SUBJECT: Design Staff Recommendation Regarding The Selection  
Of Development Teams For Chinatown Parcel R-3/R-3A

DESIGN EVALUATION OF DEVELOPMENT PROPOSALS

CHINATOWN PARCEL R-3/R-3A

JAMES KOSTARAS, URBAN DESIGN STAFF

SHADOW STUDY - SUMMER

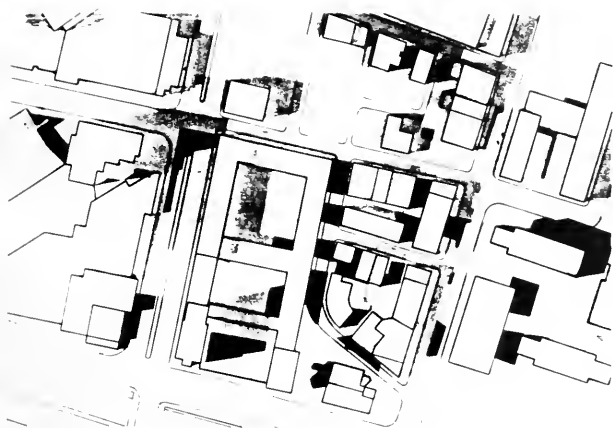
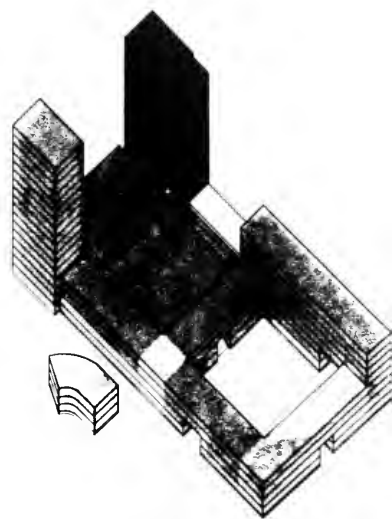
Shadow impact on the adjacent neighborhood is not extensive. The elderly tower, however, will cast a shadow on the proposed Pine Stett in-fill townhouses and the back of the church during late afternoon in autumn and spring.

The proposed courtyards enjoy a balance of sunlight and shade through most of the year. Most of the upper courtyard, however, will be in shadow during late afternoon in autumn and spring.

SOUTH ELEVATION  
MARGINAL ROAD

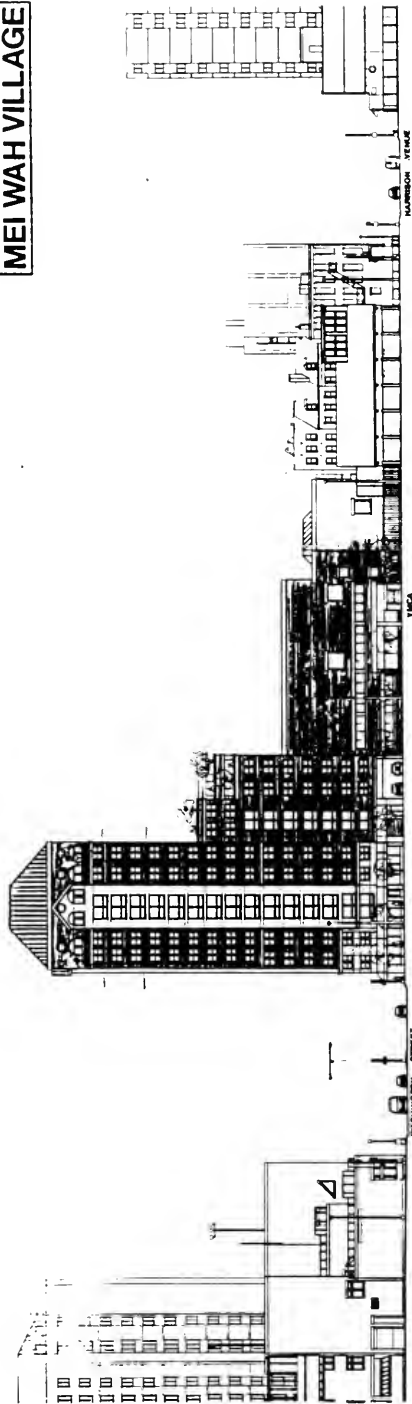
The towers seem bulky and excessively wide in relation to their respective heights; the shape and exaggerated size of the tower hip roofs seem out of scale with the existing residential architecture of Chinatown.

SHADOW STUDIES MARCH/SEPTEMBER 21 3p.m.  
CHINATOWN Parcel R-3/R-3A

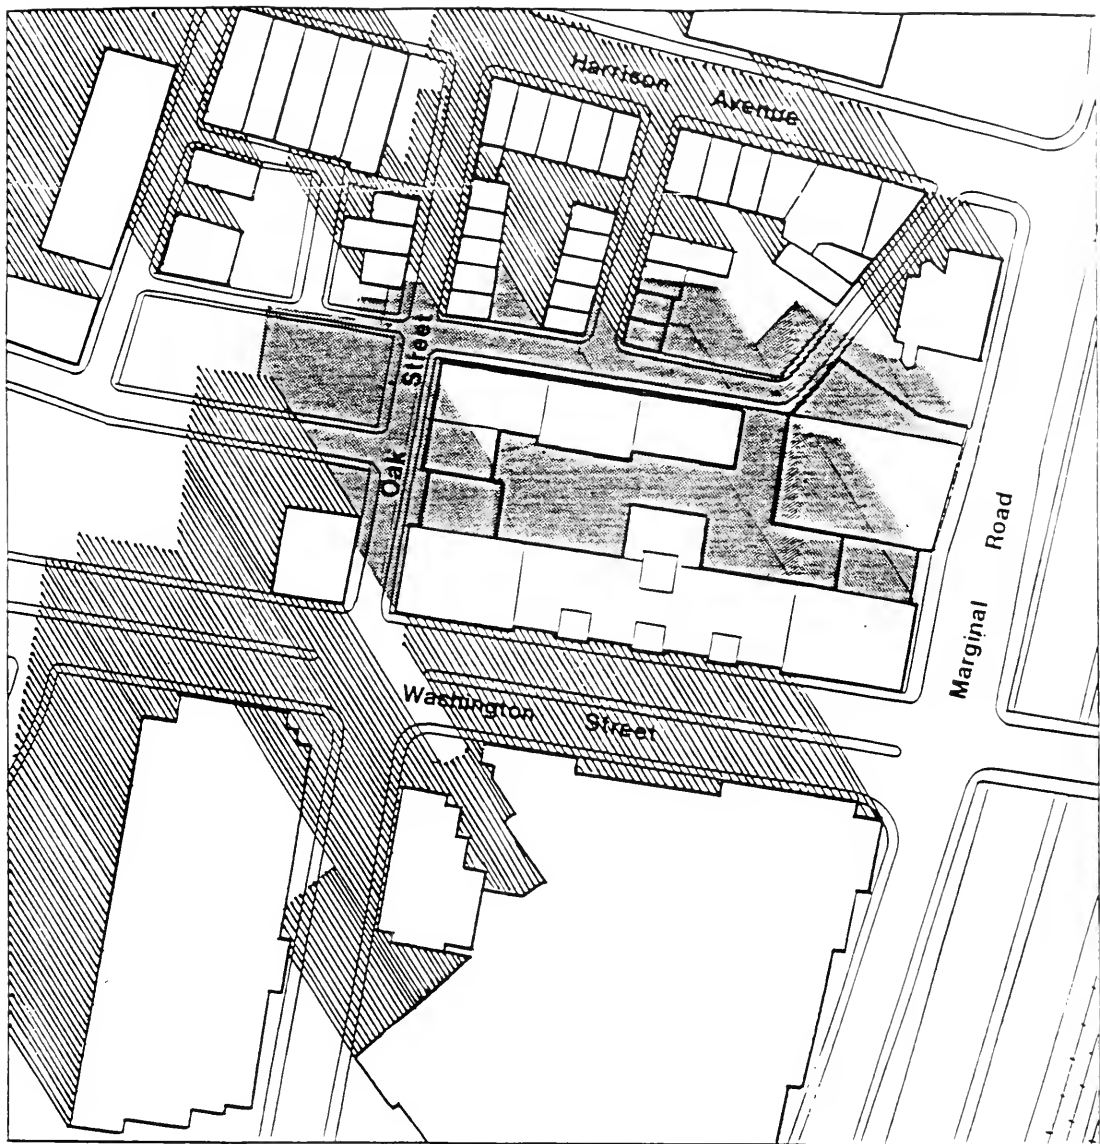
- o Shadow impact on the adjacent neighborhood:  
The Washington Street-Oak Street tower will cast shadows on the future housing site across Oak Street during afternoons throughout the year (except summer.) During autumn and spring mornings, this tower will also cast extensive shadows on the vest pocket park in front of the Quincy Tower entry.

- o Shadow impact on proposed public open space.  
The proposed courtyard will be entirely in shadow throughout the year except during summer mornings.
